# REVISED LAND-2 VISUAL RESOURCE ASSESSMENT TECHNICAL STUDY PLAN

# LEE VINING HYDROELECTRIC PROJECT FERC PROJECT No. 1388

Figure 1-1. Visual Resources Study KOPs in Relation to Recreation Use Survey Sites

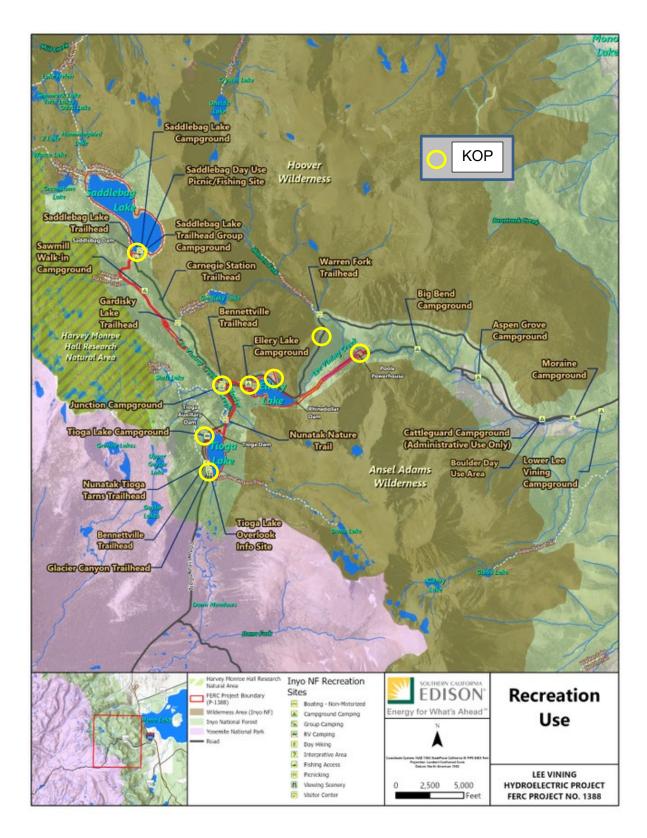
4	Adam Barnett USFS	TWG Meeting	Paraphrase of comment in meeting: There is an SCE area north of Ellery Lake that is "industrial looking" not USFS property and is in the project area. It is a bare area north of the lake with some old structures and pull offs. We would like you to include that in the Aesthetics survey.	Figure 1-1.
